Re: AOI #50 Under EPA's RCRA Corrective Action Program  
DUCO Stores – Building 34  
660 South Boulevard East, Pontiac, Oakland County, Michigan  
Facility ID No. 0-0018277  
MDEQ Confirmed Release Nos. C-0235-90, C-0776-90, and C-1831-91

## ATTACHMENT A

### MDEQ COMMENTS AND CRA'S RESPONSES

figure 4.3

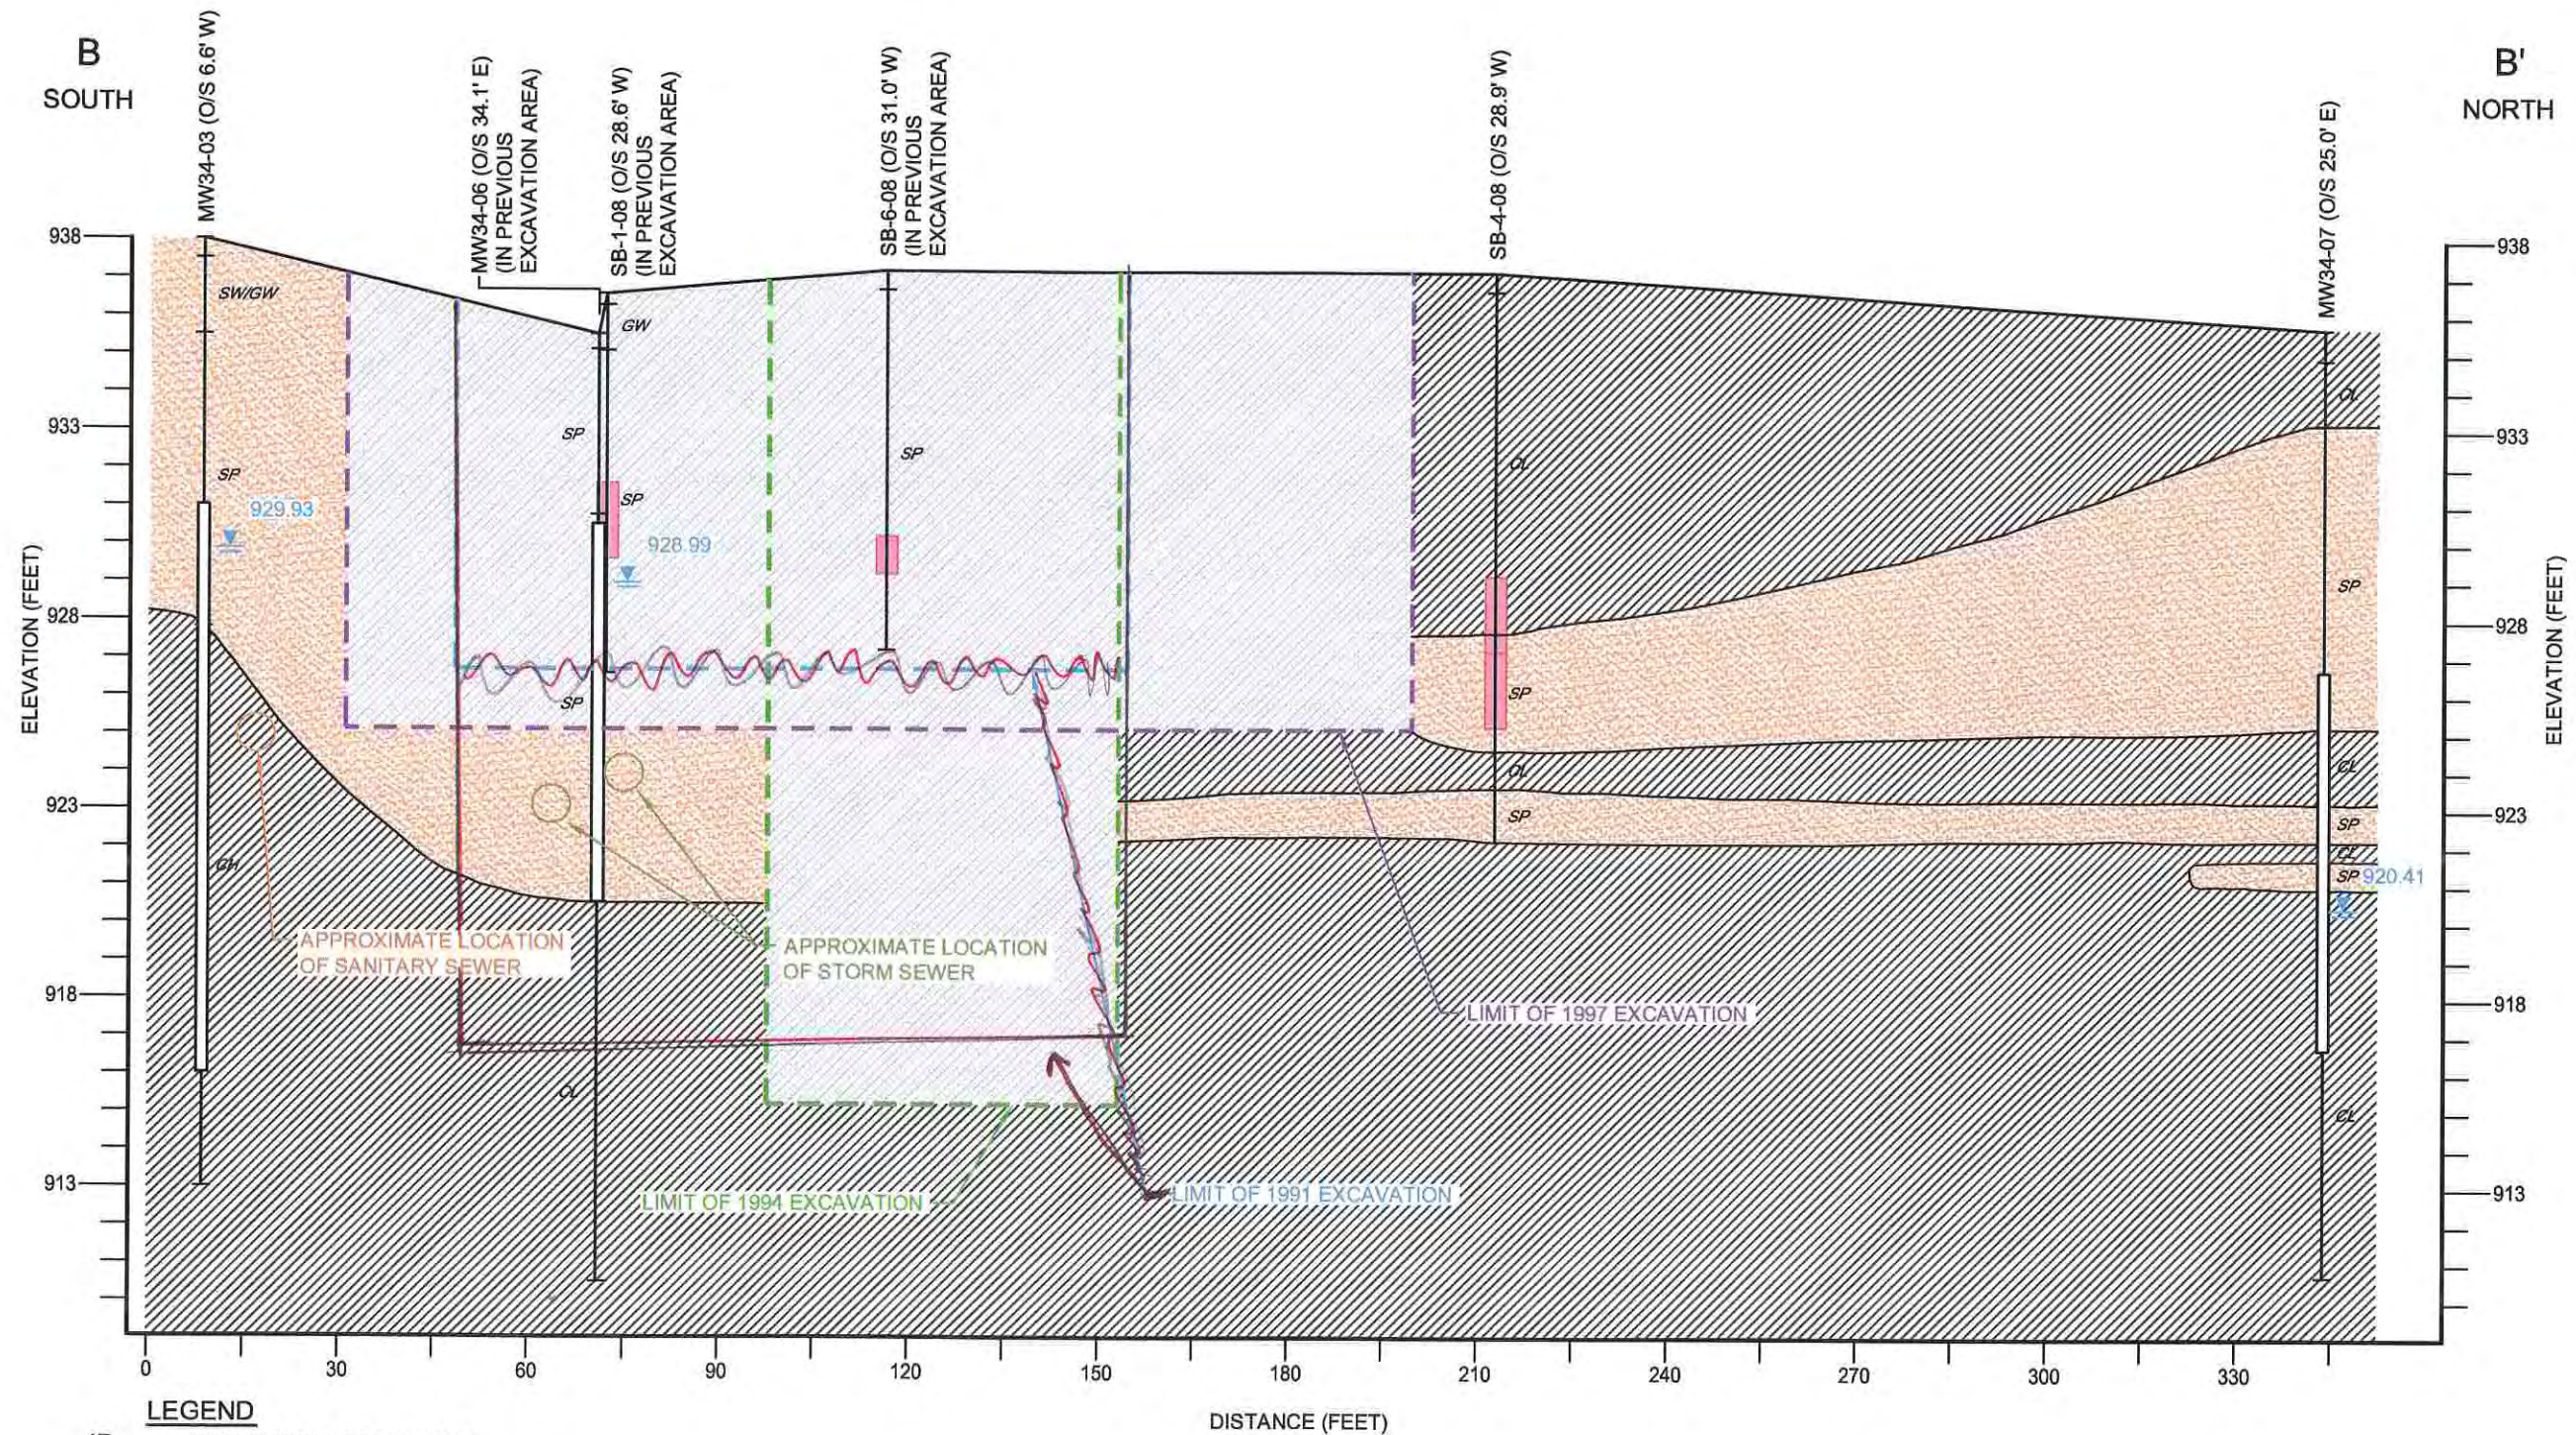
*Figures 4.1, 4.2 and 4.3 appear to be incorrect. The cross section figure only identifies the 1991 excavation as going to 10 feet. According to the text and verification sample depth, the excavation appears to have extended to a depth of 20 feet. This is not reflected in the figures. Additionally, Figure 4.2 does not display the location of the storm sewer.*

Figures 4.1, 4.2, and 4.3 with changes identified are attached.

Plate 5

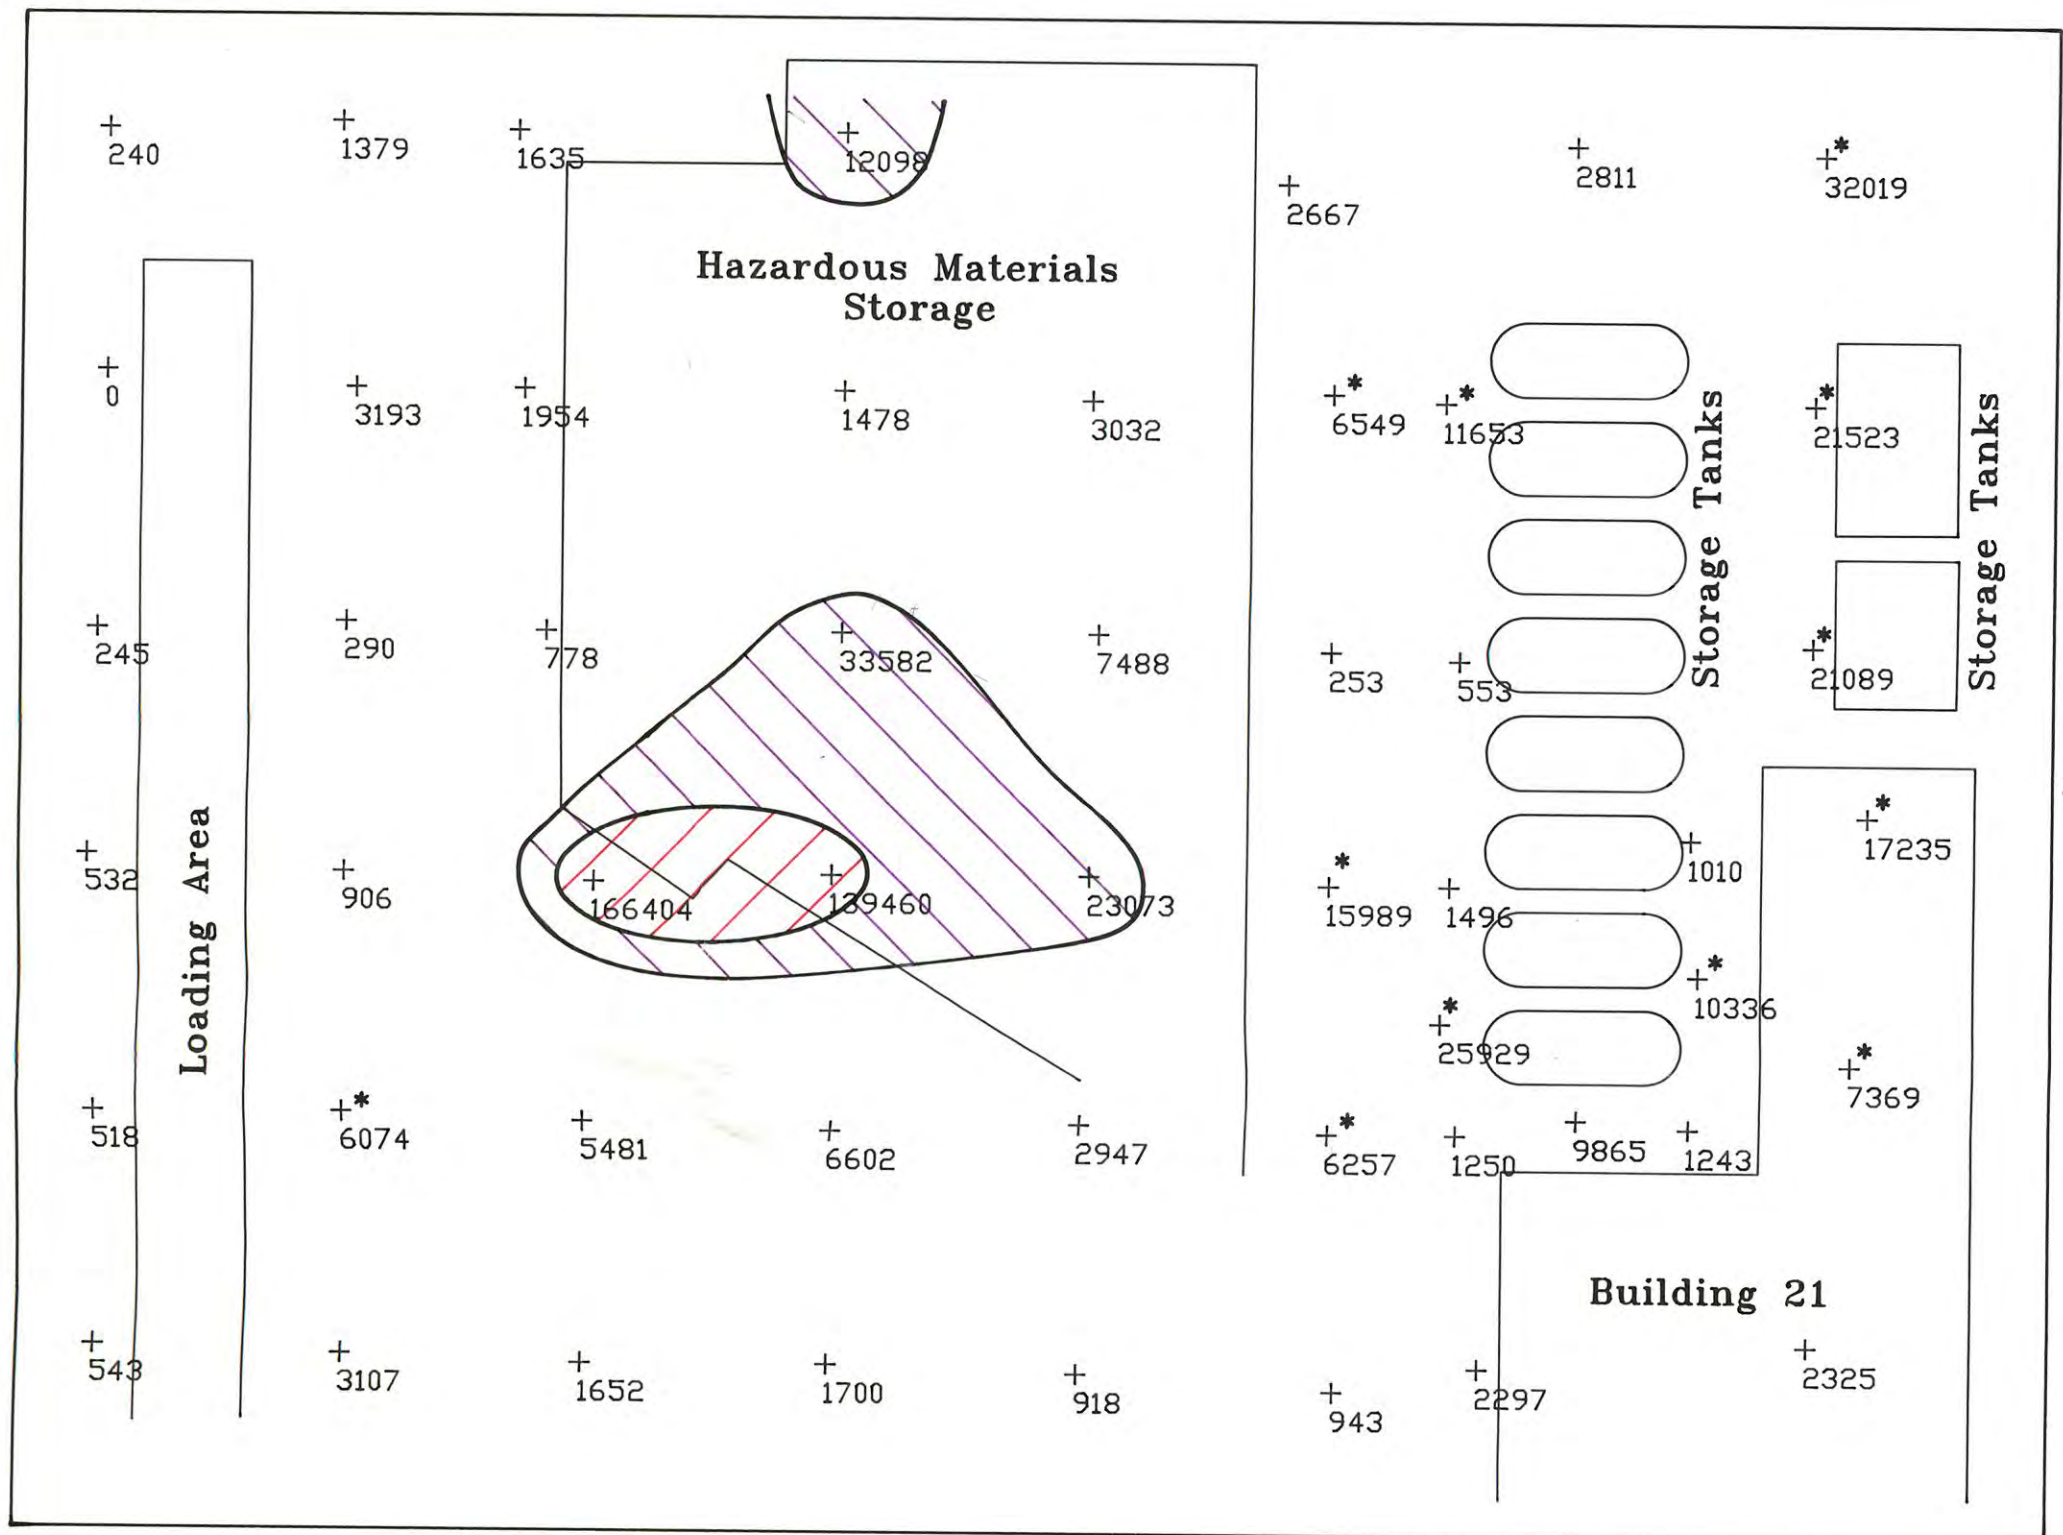
*The referenced September 1990 NERI report does not contain a map(s) of the pretrex soil gas sample locations. A map depicting the sampling points within the area of the survey should be provided.*

Plate 5 of the 1990 NERI Report with the pretrex soil gas sample locations is attached to this comment-response. The areas of identified relative flux of PCE shown on this figure are also shown on the attached Figure 1 to compare to CRA soil boring locations.
